SUBJECT: KEWAUNEE NUCLEAR POWER PLANT - EXEMPTION FROM THE
REQUIREMENTS OF 10 CFR PART 50, APPENDIX G, APPENDIX H, AND
SECTION 50.61 (TAC NO. MA8585)

UNITED STATES OF AMERICA
NUCLEAR REGULATORY COMMISSION
NUCLEAR MANAGEMENT COMPANY, LLC
KEWAUNEE NUCLEAR POWER PLANT
50-305
EXEMPTION

SAFETY EVALUATION BY THE OFFICE OF NUCLEAR REACTOR REGULATION
REGARDING AMENDMENT OF THE KEWAUNEE NUCLEAR POWER PLANT LICENSE
TO INCLUDE THE USE OF A MASTER CURVE-BASED METHODOLOGY
FOR REACTOR PRESSURE VESSEL INTEGRITY ASSESSMENT

Figure 3 - Plot of Available Data Sets Containing Both PCVN and 1T-CT or Larger Data to Estimate the Bias in PCVN T_0 Results as a (Potential) Function of the Constraint Parameter, M_0 for the PCVN data set.

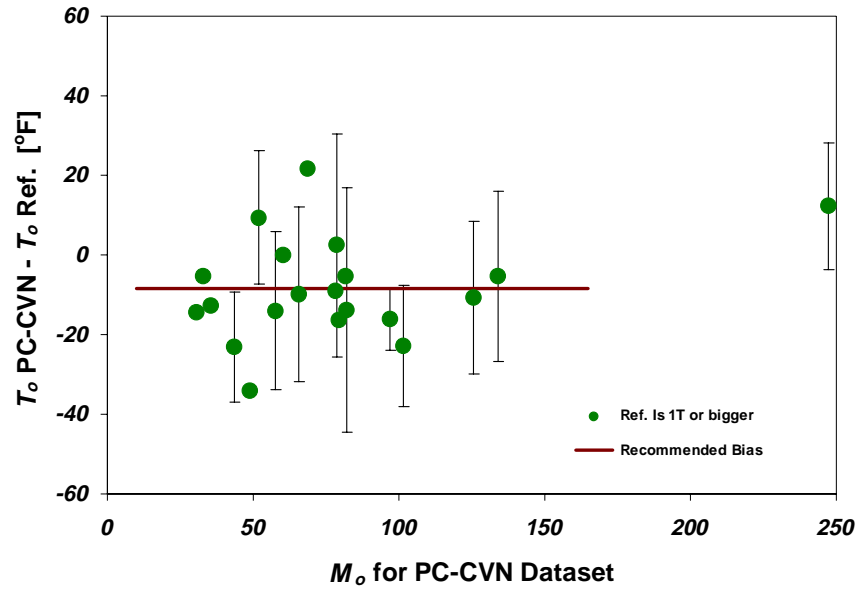
In Figure 3, “ T_0 PC-CVN” is the T_0 value determined for a particular material based upon the testing of PCVN specimen sets per ASTM E1921-97 (including the censoring limit) and “ T_0 Ref.” is the T_0 value calculated for the same material from larger specimens. Thus, the ordinate axis in Figure 3 represents the difference in calculated values of T_0 with negative

From Figure 3, the NRC staff concluded that although a statistically significant bias of 8.5 °F was evident in the data, no defined trend with M_0 was able to be resolved. The NRC staff also observed other data points for which " T_0 Ref." values could be calculated from specimens as small as 0.5T-CTs. With the inclusion of this additional data, a trend of increasing PCVN bias with decreasing M_0 may have been resolvable, but the complication of including data wherein the size (and thus the expected constraint) of the specimens used to define " T_0 Ref." was nearly the same size as the PCVN specimens would have made any such conclusions highly speculative. It can, however, be noted that with regard to addressing bias related to the licensee application, either interpretation would have yielded the same net effect in the NRC staff's overall methodology.

The NRC staff acknowledges that the lack of a definable trend in Figure 3 calls into question whether the observed bias from PCVN test results can be simply addressed as a matter of specimen constraint. Other theories have been postulated, including consideration of specimen geometry and T-stress, to explain the observed differences in PCVN and CT specimen results. The NRC staff recognizes that additional research in this area may help to better define this issue and modify the conclusions of this SE. However, the NRC staff concludes, at this time, that the assumption of a 8.5 °F bias in PCVN-based T_0 values relative to values obtained with larger size CT specimens, to be applied to each unirradiated and irradiated PCVN data set in the licensee submittal, is adequate to address this potential source of non-conservatism in the NRC staff's methodology as given in Appendix A to this SE.

The methodology developed by the NRC staff, however, includes sufficient flexibility to incorporate specific bias values for each of the four PCVN data sets relevant to this evaluation of the KNPP RPV circumferential weld should additional information demonstrate that different bias values are appropriate. To provide this flexibility, each of these four data sets must be addressed separately since the effect of bias on the evaluation of the shift in T_0 must be assessed given the NRC staff's methodology discussed in Section 4.3.2 above. As such, the effect of "accounting for bias in PCVN data" in the NRC staff's methodology cannot be easily discussed as a stand alone item, but must instead be presented as it is integrated into achieving results from the overall NRC staff methodology. This integration of bias into the NRC staff's methodology is addressed in Appendix A and discussed further in Section 4.3.5 below.
